From: Fennessy, Christopher [christopher.fennessy@Rocket.com]
Sent: 8/3/2018 6:58:18 PM
To: MacNicholl, Peter@DTSC (Peter.MacNicholl@dtsc.ca.gov) (Peter.MacNicholl@dtsc.ca.gov)
[Peter.MacNicholl@dtsc.ca.gov]; MacDonald, Alex@Waterboards (Alex.MacDonald@waterboards.ca.gov)
[Alex.MacDonald@waterboards.ca.gov]; Keller, Lynn [Keller.Lynn@epa.gov]
Subject: FW: [EXTERNAL] FW: investigation area
Attachments: ATT00001.txt; 154153_107_Figure_2_source_areas_RAP.pdf

Attached is a revised figure 2 for the RAP and the shape files to provide to the CAG so they can see the acreages of each area.

Subject: [EXTERNAL] FW: investigation area

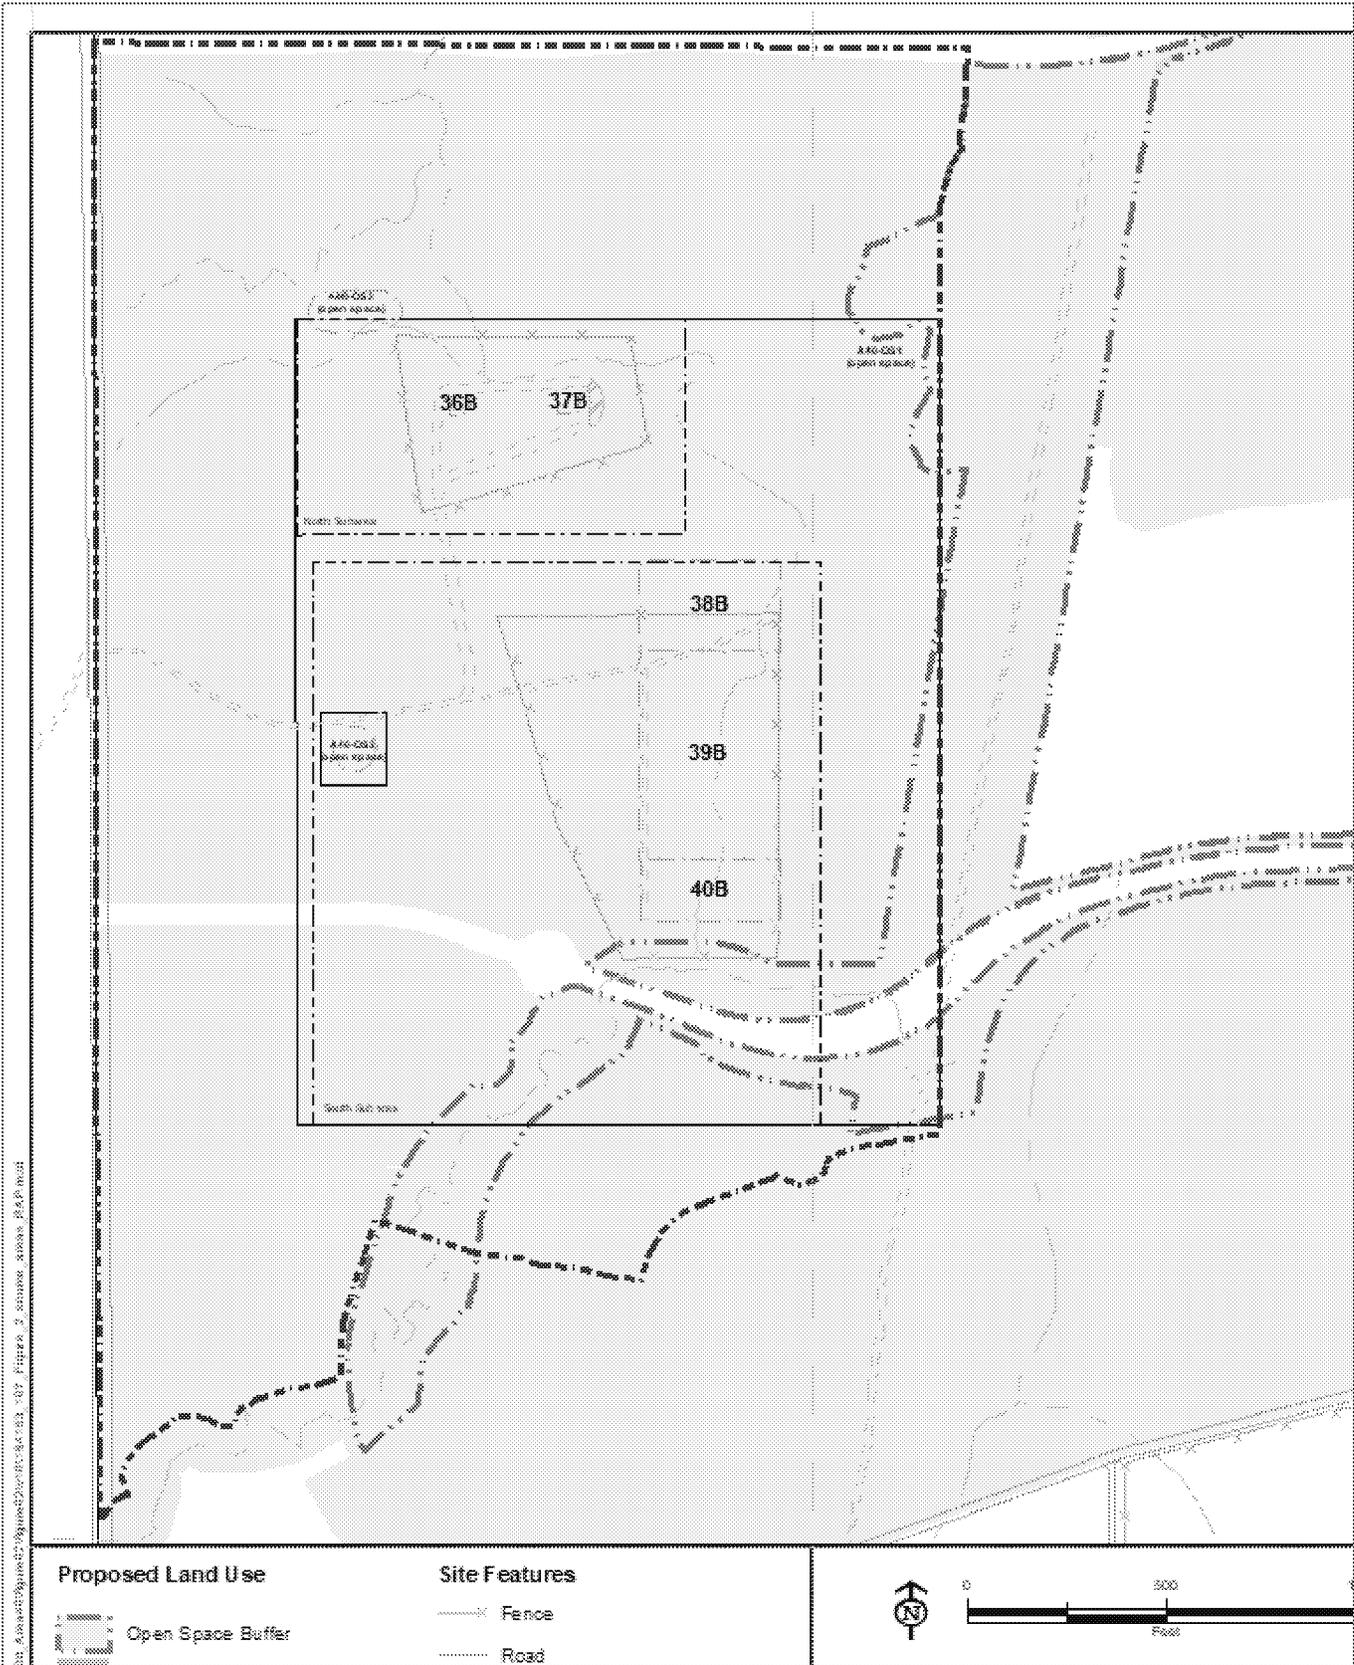
Please add Open Space area acreage and Park area acreage. Make sure callouts point to area referred. Currently Area 40 callout does not reach the Area 40 rectangle.

The screen shots below are from the CAD figure you provided and Figure 2 from the RAP, respectively. Notice the Investigation area between the two differs in the southwest corner. Is the CAD figure you provided correct?

Thanks. We will create the shape file for the CAG to include the investigation boundary from Figure 2 and the Area 40 property boundary from the CAD file. On Figure 2 we call out the acreage of both areas.

Original figure is correct (red line for investigation area). I was eyeballing when I created mine.
